**ZONING AMENDMENT
& SUBDIVISION STAFF REPORT****Date: October 6, 2016**

<u>NAME</u>	Blankenship Enterprises
<u>SUBDIVISION NAME</u>	Blankenship Addition to Springhill Avenue Subdivision
<u>LOCATION</u>	1305 and 1307 Spring Hill Avenue (South side of Spring Hill Avenue, 90' ± West of North Ann Street).
<u>CITY COUNCIL DISTRICT</u>	District 2
<u>PRESENT ZONING</u>	R-1, Single-Family Residential District, and B-3, Community Business District
<u>PROPOSED ZONING</u>	B-3, Community Business District
<u>AREA OF PROPERTY</u>	1 Lot/ 2.3 Acres
<u>CONTEMPLATED USE</u>	<p>Subdivision to create 1 legal lot of record from 1 legal lot of record and 1 metes-and-bounds parcel, and Zoning to rezone the site from R-1, Single-Family Residential District and Community Business District to Community Business District, to eliminate split zoning.</p> <p>It should be noted, however, that any use permitted in the proposed district would be allowed at this location if the zoning is changed. Furthermore, the Planning Commission may consider zoning classifications other than that sought by the applicant for this property.</p>

SITE PLAN

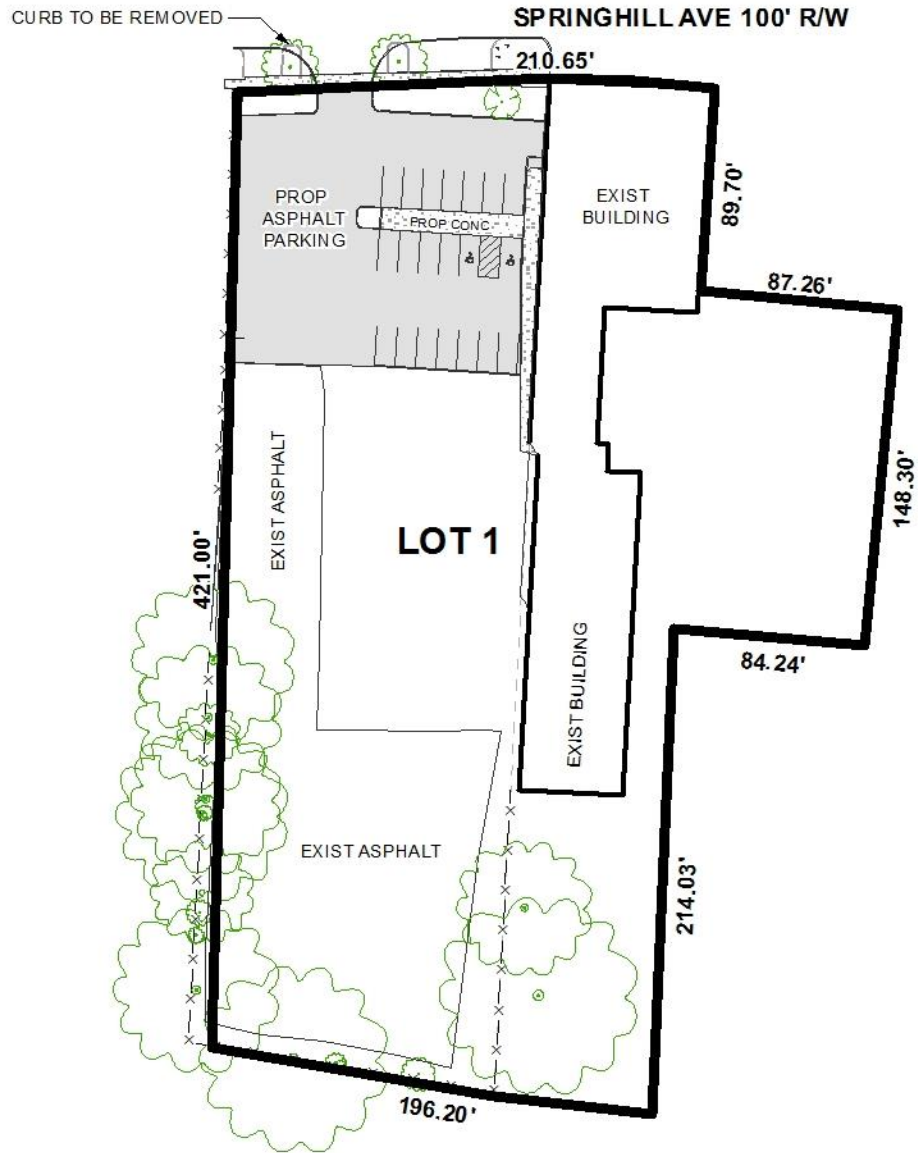
The site plan depicts 20 new parking spaces, of which 2 spaces are handicap accessible, and a concrete walk. Based on aerial photos it appears that there are additional parking spaces on site located by North Ann Street; however the site plan does not show any existing parking.

With regards to tree and landscaping, it appears that one new tree is proposed as part of the new parking area.

The site currently has three existing curb-cuts to Springhill Avenue and three existing curb-cuts to North Ann Street based on aerials. It appears that the applicant proposes to revise the curb-cuts onto Springhill Avenue, eliminating two of the three. The site should be limited to one curb cut to Springhill Avenue and its existing two curb cuts to Ann Street, with the size, location and design to be approved by ALDOT (where applicable) and Traffic Engineering and conform to AASHTO standards

The 25-foot minimum building setback line is not depicted on the preliminary plat. The plat should be revised to depict the 25' minimum building setback line along both street frontages. It should be noted, any redevelopment or new construction must comply with the minimum 25' building setback requirements.

- 1) revision of the Final Plat to depict the 25-foot minimum building setback lines along both street frontages;
- 2) retention of the lot sizes in square feet and acres;

- 3) placement of a note on the Final Plat stating the site is limited to one curb cut to Springhill Avenue, and two curb cuts to Ann Street, with size, location and design to be approved by ALDOT (where applicable) and Traffic Engineering and conform to AASHTO standards;

DETAIL SITE PLAN

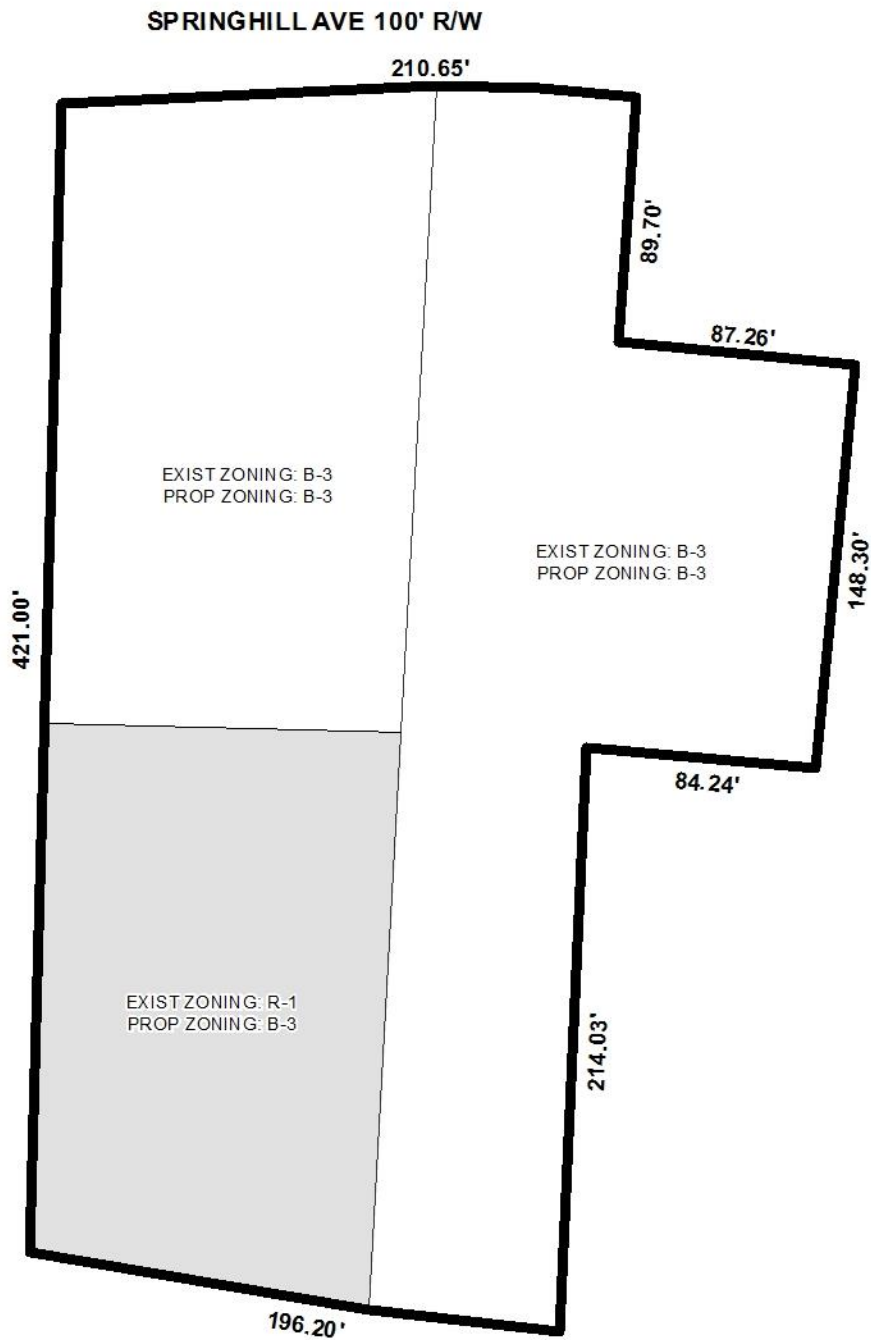
setback 10 feet from the Springhill Avenue right-of-way line: this may allow room for some landscape screening of the parking.
